Board File Number: EB-2007-0709

Herein are my comments to the "Proposed Amendments to the Distribution System Code" released March 31, 2009

Response to OEB Proposed Amendments to the Distribution System Code. Board

File Number: EB-2007-0709.

PRI. NEUTRAL VOLTAGE

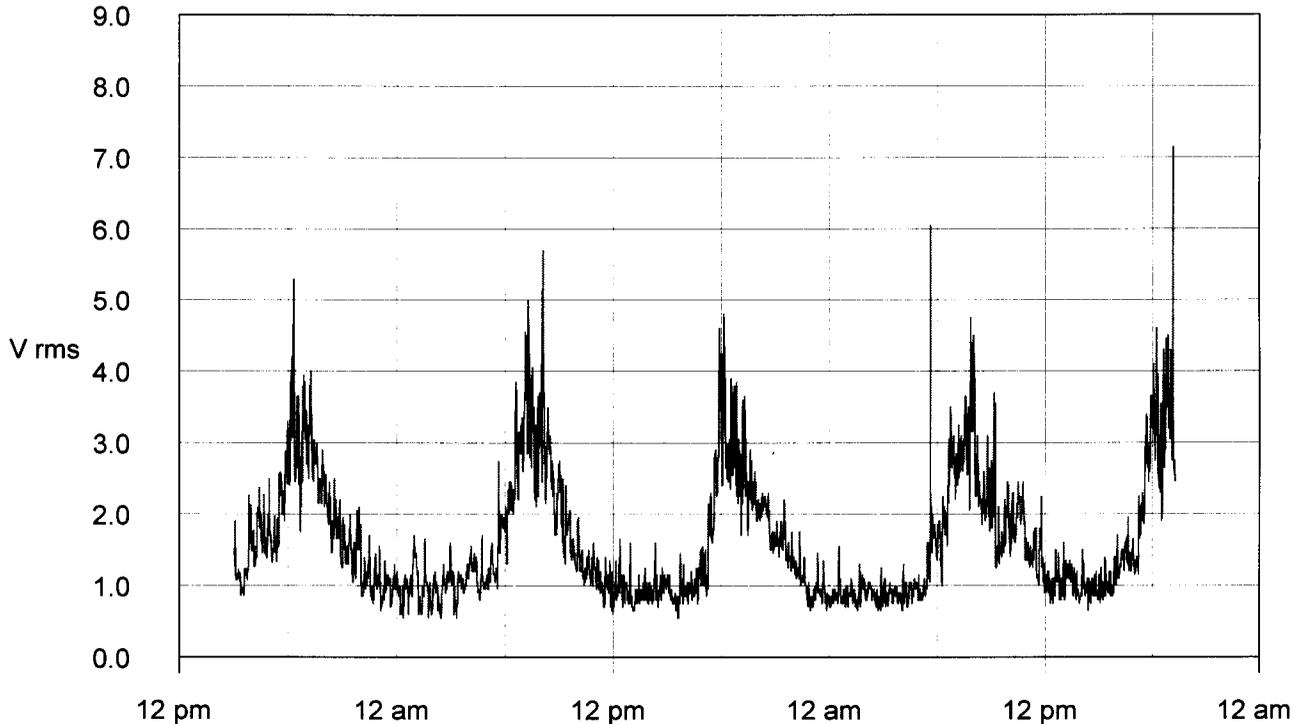
THIS DATA LOGGING SHOWS HOW THE PRIMARY NEUTRAL VOLTAGE VARIES OVER A 48 HOUR PERIOD .

LOW FARM GROUND RESISTANCE TO EARTH

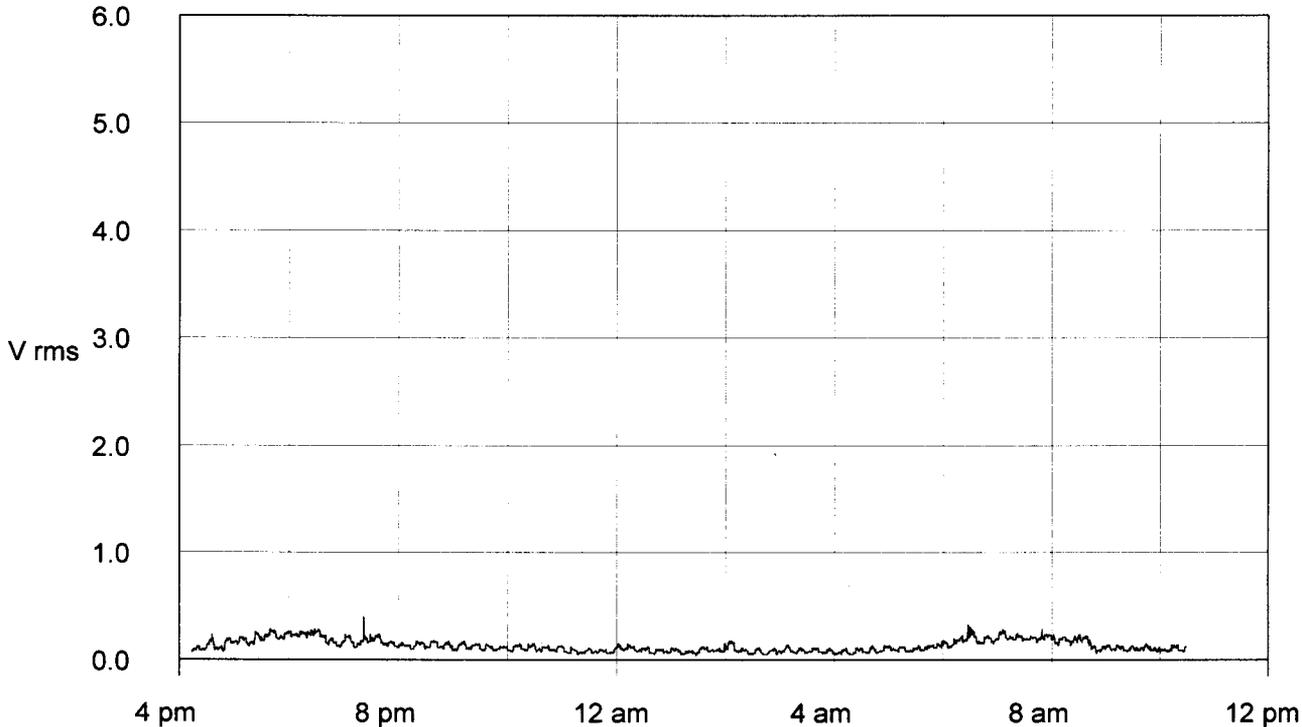
THIS DATA LOGGING SHOWS A VERY LOW VOLTAGE ON A FARM GROUNDING SYSTEM .THE MEASURED RESISTANCE OF THE GROUNDING SYSTEM TO EARTH WAS .2 ohms . ACCORDING TO ANY COW CONTACT READINGS AND CALCULATIONS THERE SHOULD NOT BE A PROBLEM WITH STRAY VOLTAGE . A CURRENT MEASUREMENT TAKEN AT .26 VOLTS SHOWED THAT THERE WAS 1.3 AMPS OF CURRENT COMING BACK ONTO THE GROUNDING SYSTEM FROM HYDRO' S PRI. NEUTRAL .
